# SHORT STOP DEVELOPMENT PLAN MINOR AMMENDMENT

5819 PALMER PARK BLVD.  
COLORADO SPRINGS, COLORADO 80915

Add PCD File No. PPR1847

**1 DETAIL SITE PLAN**  
SCALE: 1:20

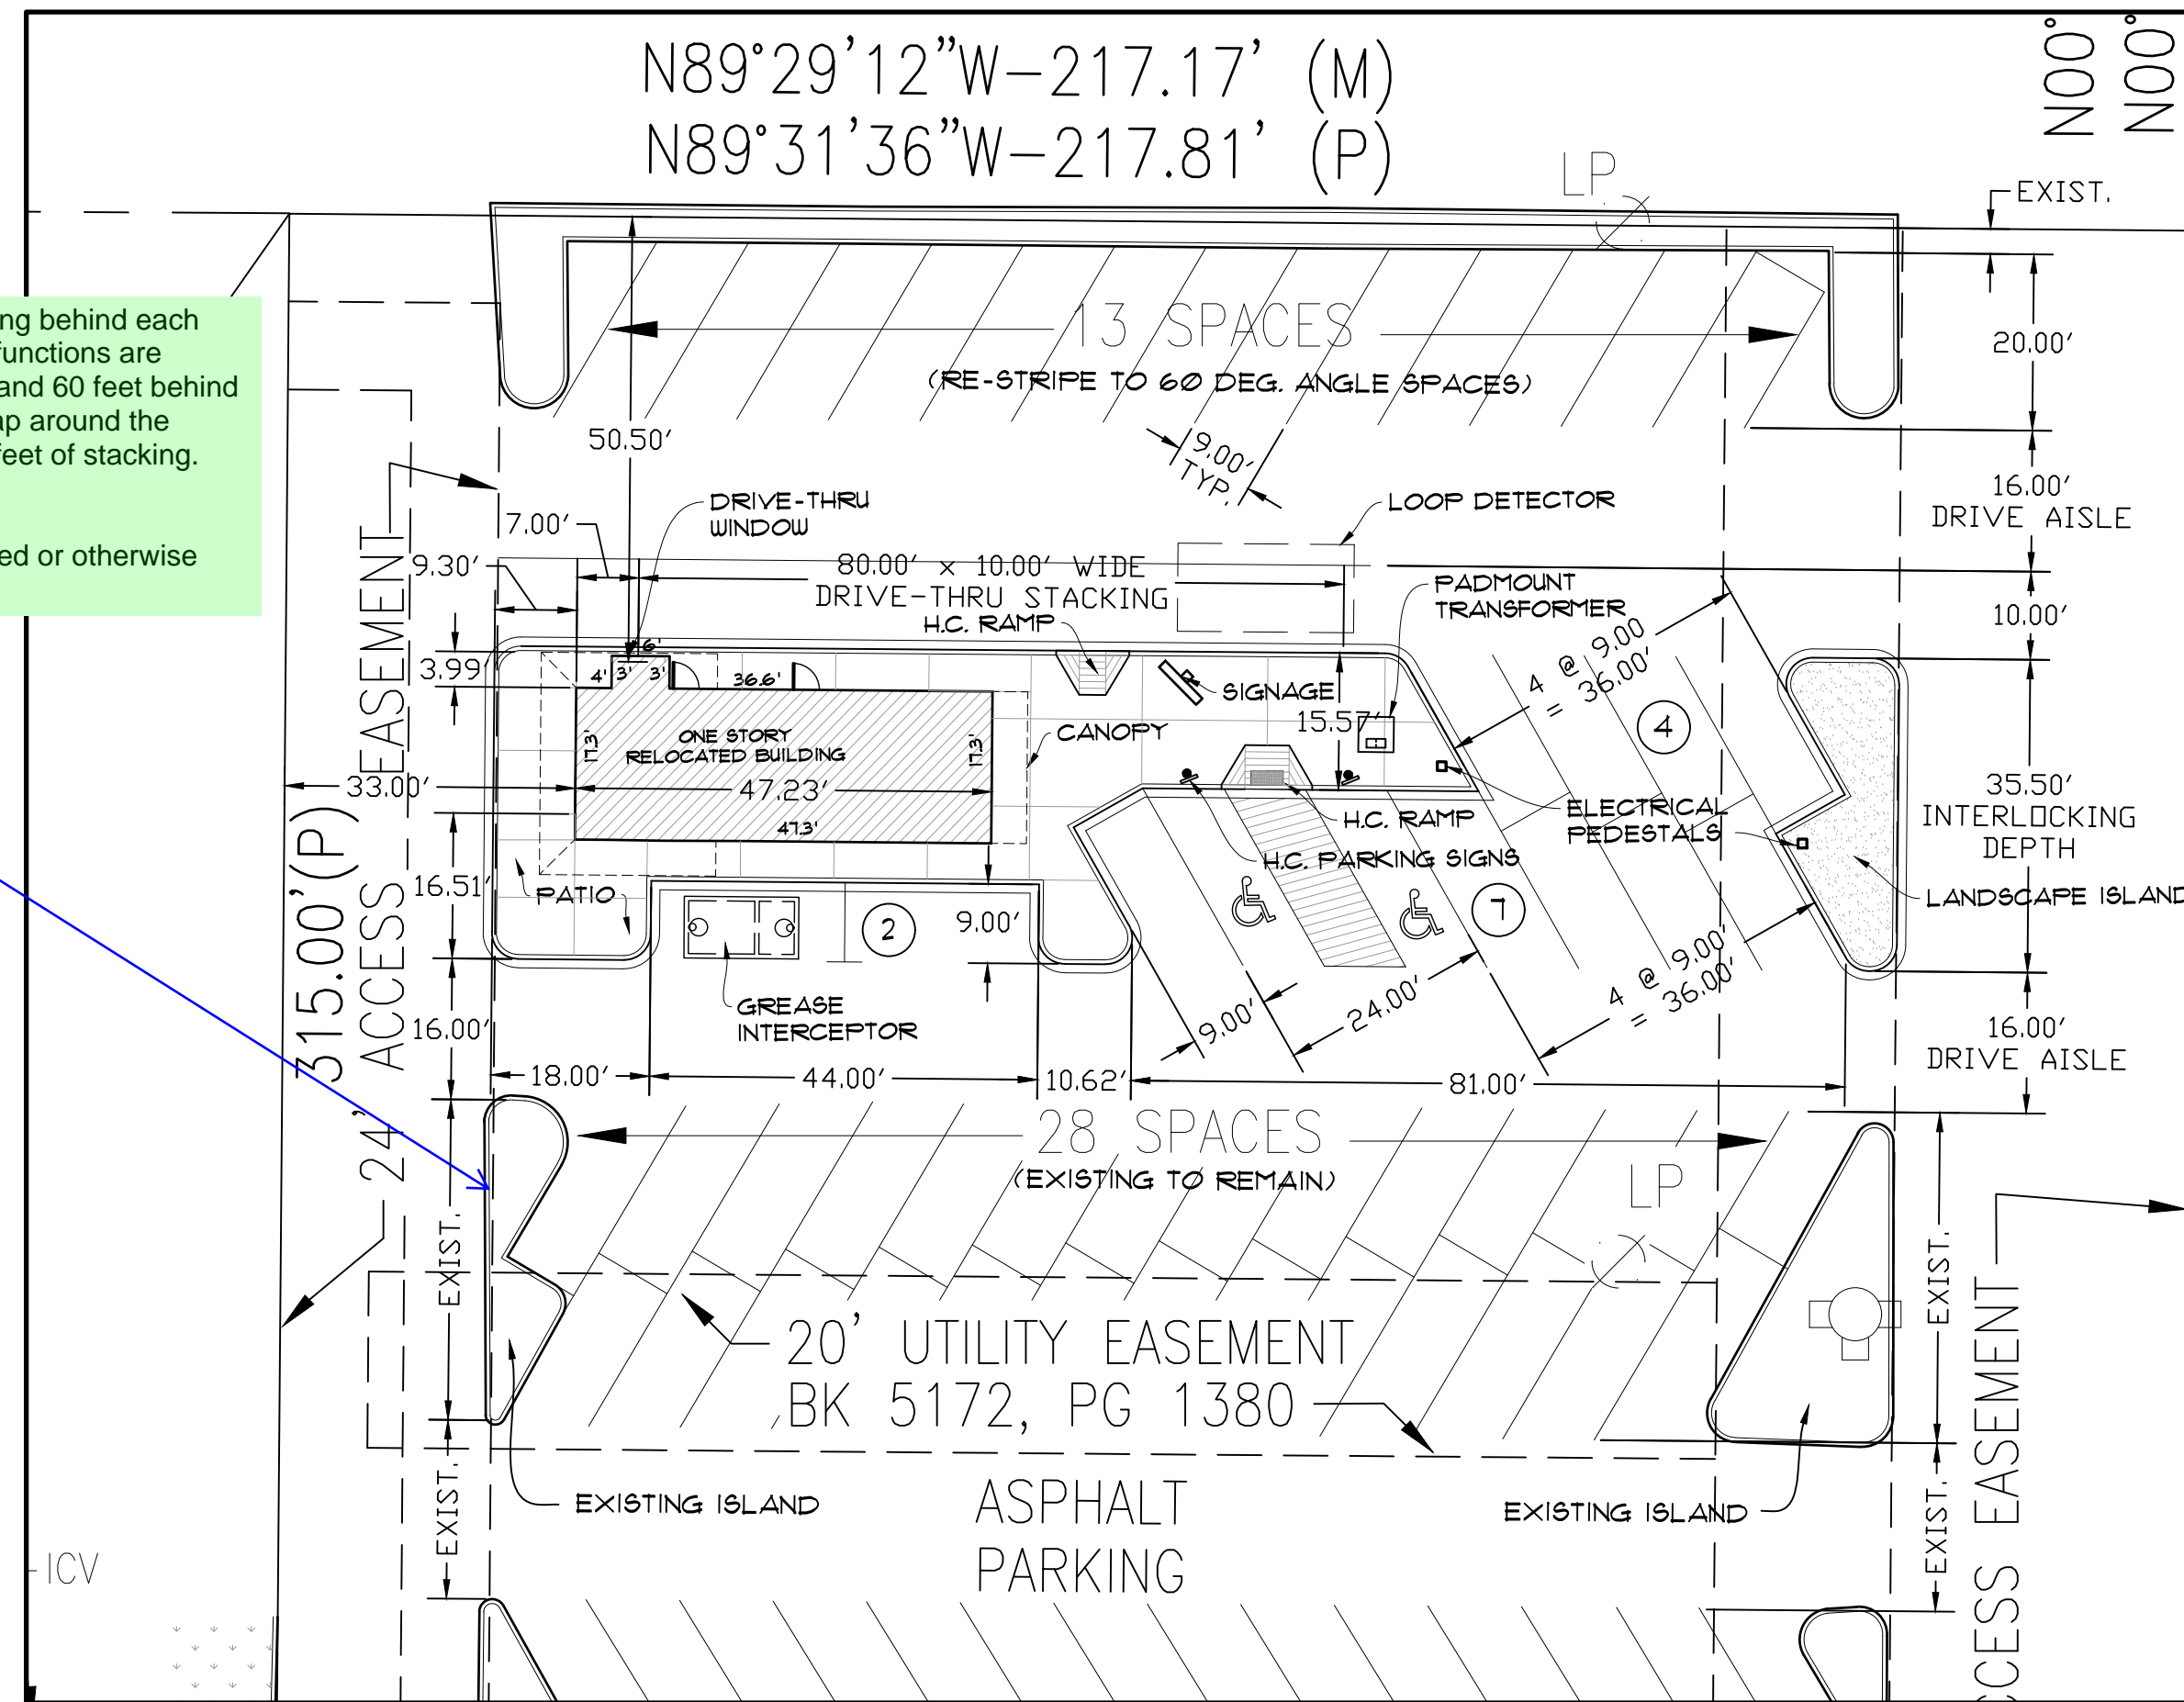
Restaurants shall provide 90 feet of stacking behind each order board and pick-up window, or if the functions are separated, 30 feet behind an order board and 60 feet behind the pick-up window. The stacking may wrap around the building. -call out order board or show 90 feet of stacking.

Drive-through lanes shall be striped, marked or otherwise distinctly delineated.

Label the proposed sand filter basin
